STATE OF IDAHO
DEPARTMENT OF WATER RESOURCES
BENEFICIAL USE FIELD REPORT

A. GENERAL INFORMATIONPermit No. 21-132091. Owner YRROW ON LLC C/O AMBER BOYCEPhone No. 208-360-5200Current address 4125 SAWTELLE PEAK ROAD, ISLAND PARK, IDAHO, 834292. Examiner's name PAUL SCORESBYEXAM DATE JULY 30, 20183. Accompanied by LANCE BOYCEEmail LANCE@MONOSLABEZFORM.COMAddress P.O. BOX 371 ISLAND PARK, IDAHO 83429Relationship to permit holder OWNERPhone No. 208-360-52004. Source GROUNDWATER

Permit # 21-13209

6" HIGH CAPACITY PUMPS - 75 GPM

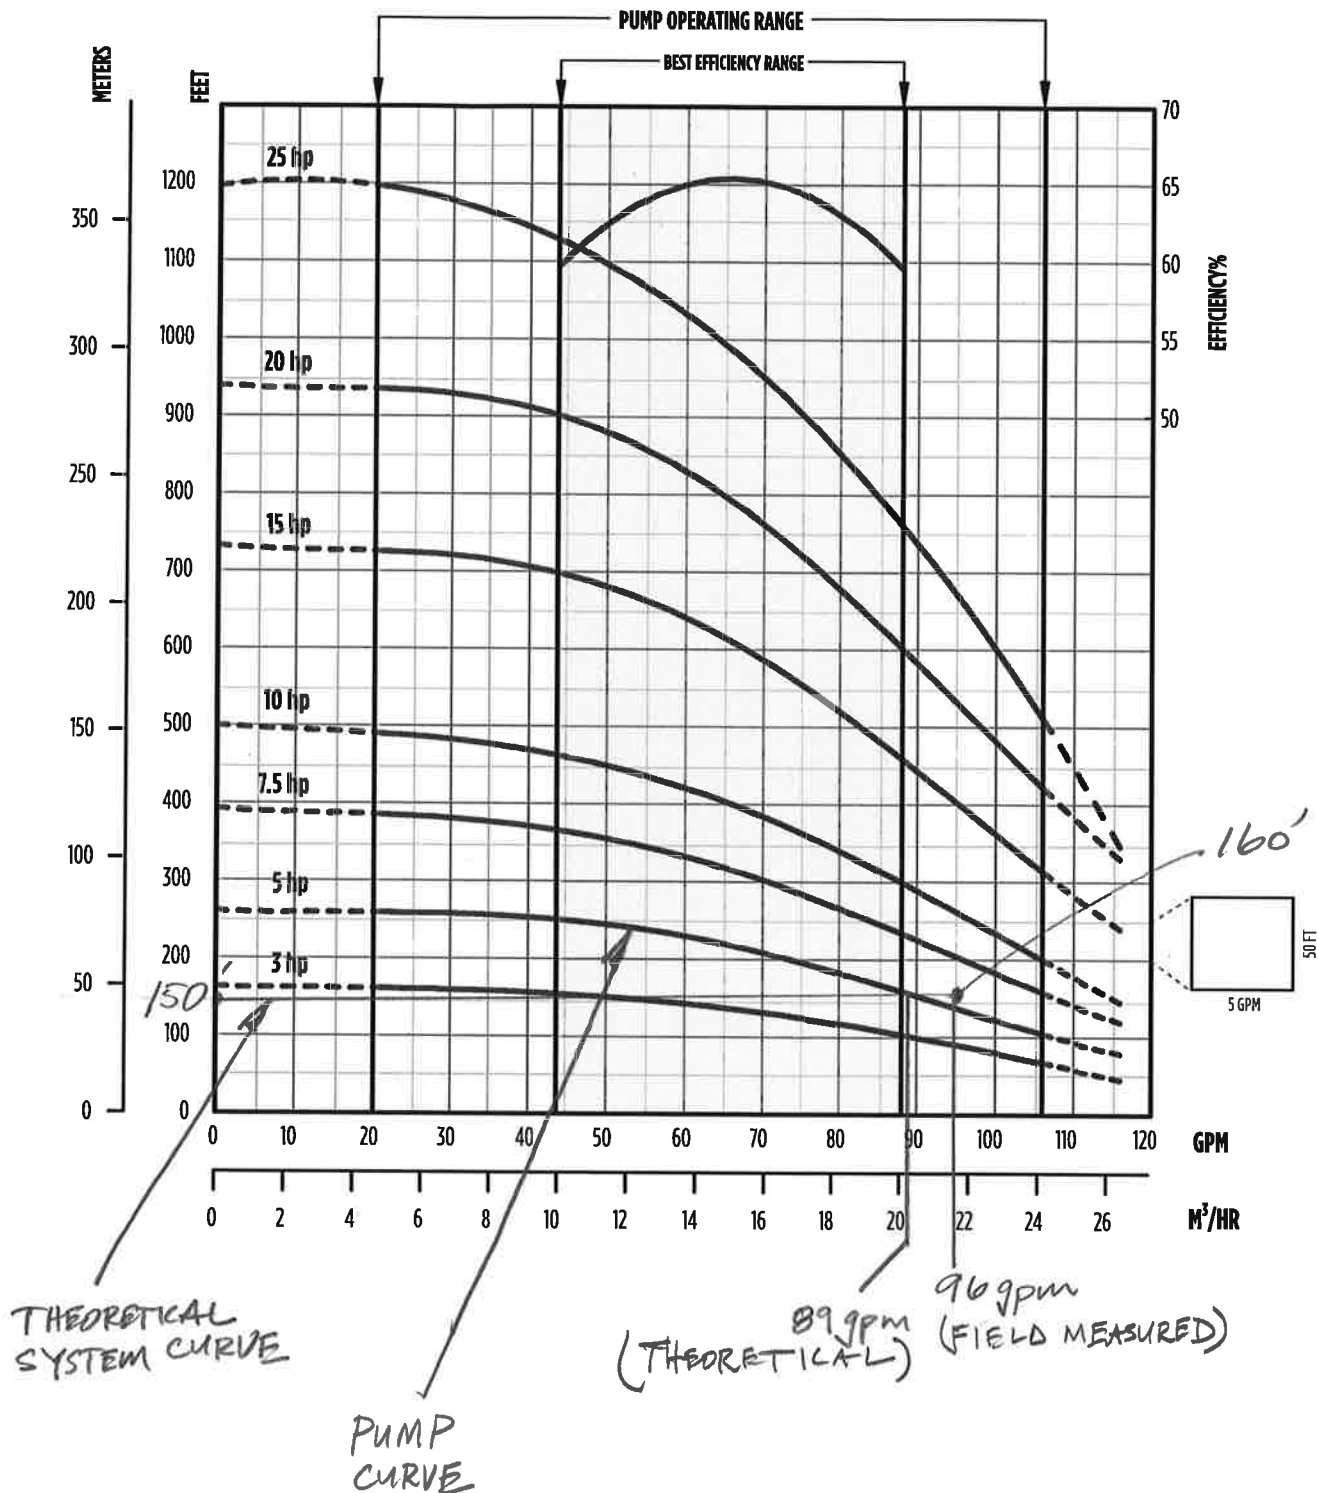
I just went through your revised field examination, and you did a very good job of clarifying the diversion rate. Originally, I did not have access to the pump test that was done, so I didn't realize that the pumping water level maintained such a high level. Using your information, the theoretical flow rate I came up with was 92 gpm, which is much more reasonable than what I was finding upon my first review. The pump curve also helps to define the diversion rate. The pump curve is -7% and my adjusted theoretical was -4% of the measurement that you made. It appears as though the pump was operating at approximately 73% efficiency, which is reasonable for small submersible pumps. I feel I can easily explain the difference in the measurements now.

Pump curve illustrates that Q should be 89 gpm instead of 96 gpm, which is a pretty good fit considering the assumptions made. Therefore accept results.
